Access Compliance Report

Public Rights-of-Way

(Curb Ramps)

Intersection ID: 30216	Main Street: HIDDEN_CREEK_DR	Cross Street: TANSY_DR	Location: W
ADA ID: C15CDA9885BA	Ramp Type: PerpDiag	Initial Pass/Fail: Fail	Overall Compliance: No
Severity Score: 22.5			
Codes/Mitigation Info/Possible Solution		Field Measurements/Component Compliance

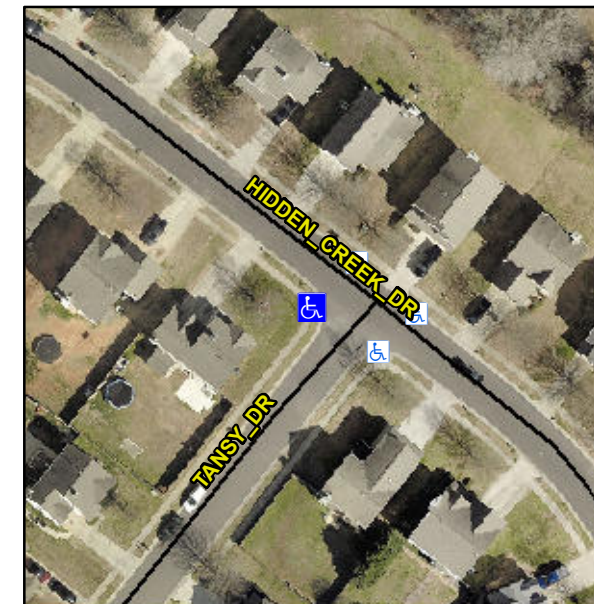
Not Found, R304.5.1, R304.2.2, R304.5.3

Compliance	Description	Data	Compliance	Description	Data
N/A	Ramp Length (in)	47.5	No	Ramp Slope (%)	9.1
No	Ramp Width (in)	39.5	No	Ramp XSlope (%)	2.9
N/A	Flare Type LT	N/A	N/A	Flare Type RT	N/A
N/A	Flare Slope LT (%)	N/A	N/A	Flare Slope RT (%)	N/A
N/A	Flare Traversable LT?	N/A	N/A	Flare Traversable RT?	N/A
N/A	Landing Length (in)	N/A	N/A	DWS Provided?	N/A
N/A	Landing Width (in)	N/A	N/A	DWS Contrast?	N/A
N/A	Landing Slope (%)	N/A	N/A	DWS Length (in)	N/A
N/A	Landing X Slope (%)	N/A	N/A	DWS Full Width?	N/A
N/A	Landing Curb? (Y/N)	N/A	N/A	DWS Offset (in)	N/A
N/A	Shared Landing?	N/A			
N/A	Gutter Ponding?	N/A	N/A	Gutter Slope (%)	N/A
N/A	Gutter Lip Ht (in)	N/A	N/A	Gutter X Slope (%)	N/A
N/A	Painted X Walk1?	No	N/A	Painted X Walk2?	No
	X Walk 1 Direction	To SE		X Walk 2 Direction	To NE
N/A	X Walk 1 Width (in)	N/A	N/A	X Walk 2 Width (in)	N/A
	X Walk 1 Slope (%)	0.4		X Walk 2 Slope (%)	0.7
	X Walk 1 X Slope (%)	1.9		X Walk 2 X Slope (%)	1.7

Remove & Replace Curb Ramp With Two New Directional Ramps or Equivalent.
